Review of two flood mitigation projects: Bragg Creek / Springbank off-stream flood storage and McLean Creek flood storage

Date	Our reference	Number of pages
October 7, 2015	1220924-001-BGS-0001-lk	8
From	Direct line	E-mail
Hans van Duijne	+31(0)88335 7776	hans.vanduijne@deltares.nl

Review of two flood mitigation projects: Bragg Creek / Springbank off-stream flood storage and McLean Creek flood storage

Figure 1 Location and reservoir area of the Elbow River Dam at McLean Creek (MC1)

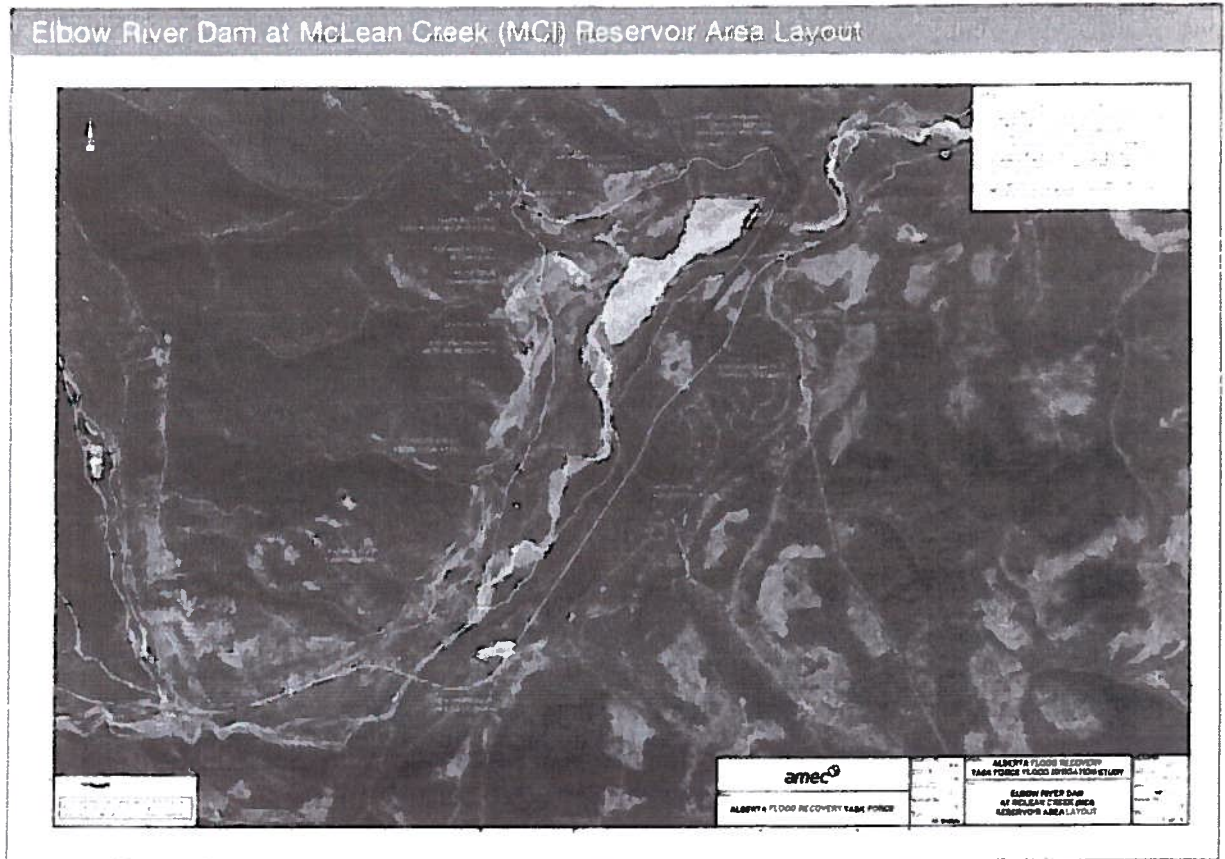
As described by AMEC (2014a), this project involves building an earth-fill dam across the main stem of the Elbow River. The proposed earth-fill dam (main embankment) traverses a river gorge, which is approximately 110 m wide at the base and is steep walled for a height of about 28 m (maximum height 50m). The dam includes a combined concrete outlet/service spillway structure for discharging normal and flood flows, and includes an auxiliary earth cut channel spillway to protect the dam from extreme floods up to the Probable Maximum Flood (PMF) event. The permanent outlet/service spillway is a gated conduit structure with its intake invert located about 21 m above the valley bottom. The concrete gates would typically be left in a wide-open position thereby allowing free passage of river water with minimum rise of the reservoir level during normal flow conditions (i.e., non-flood). The gates would be strategically closed during flood events thereby holding back a significant portion of the flow in reservoir storage. The concrete structure also serves as an emergency spillway designed to let above-design floods pass, thereby protecting the dam from potential overtopping or overloading and associated catastrophic failure.

The conceptual design includes a small permanent pool in the valley bottom, permanently containing approximately 4,000 dam³ of water as dead storage. This storage should prevent incoming larger bottom sediment from plugging the intake area. There is no low level outlet to release the dead storage. Additional water could be contained above the dead storage El. 1,398.0 m (i.e., multi-use storage) by regulating the permanent outlet gates. The potential benefit and/or need for multi-use storage at this site has not yet been reported.

Figure 2 Location and reservoir area of the Springbank off-stream storage project (SR1)

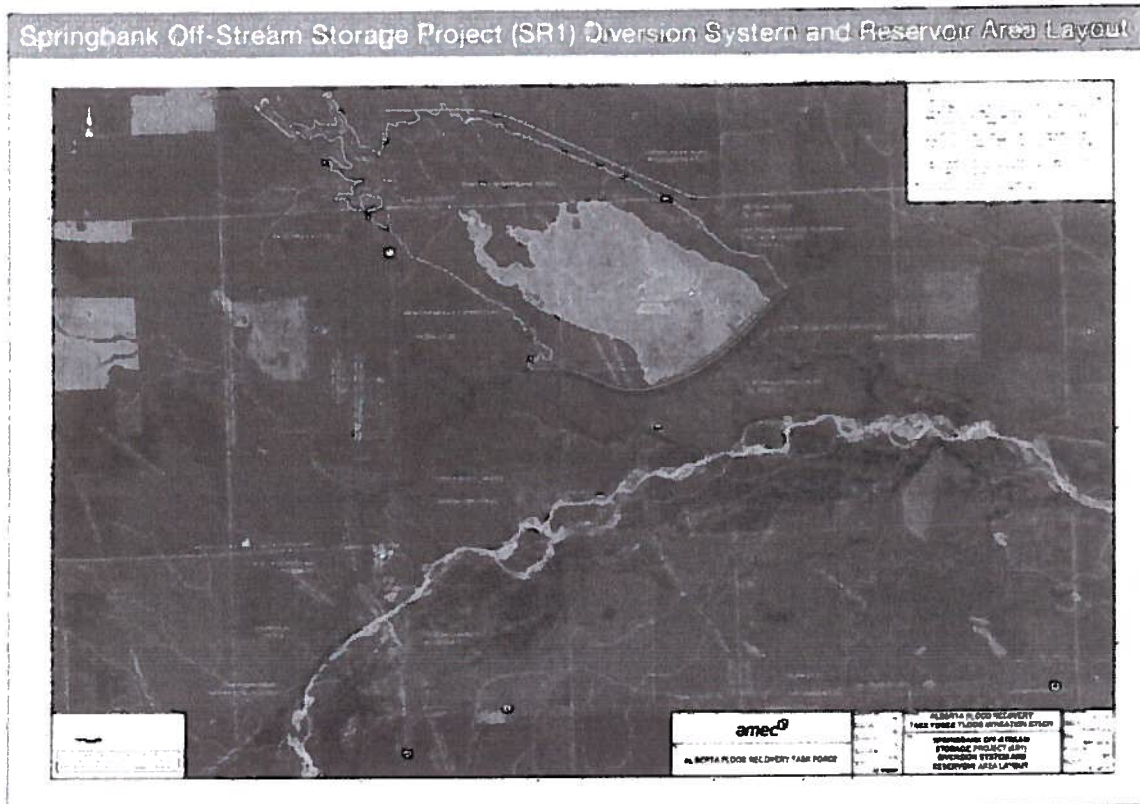
¹ In the Stantec adjusted design (April 2015) this seems to be removed, only a 40 m wide spillway/sluiceway in the river bed is assumed. Also Stantec adjusted the diversion channel capacity to 600 m³/s, with design 6.4 m water depth. Also the storage dam is a bit higher and a few 100 m downstream. Same intake location from the river, and same outlet structure at the dam
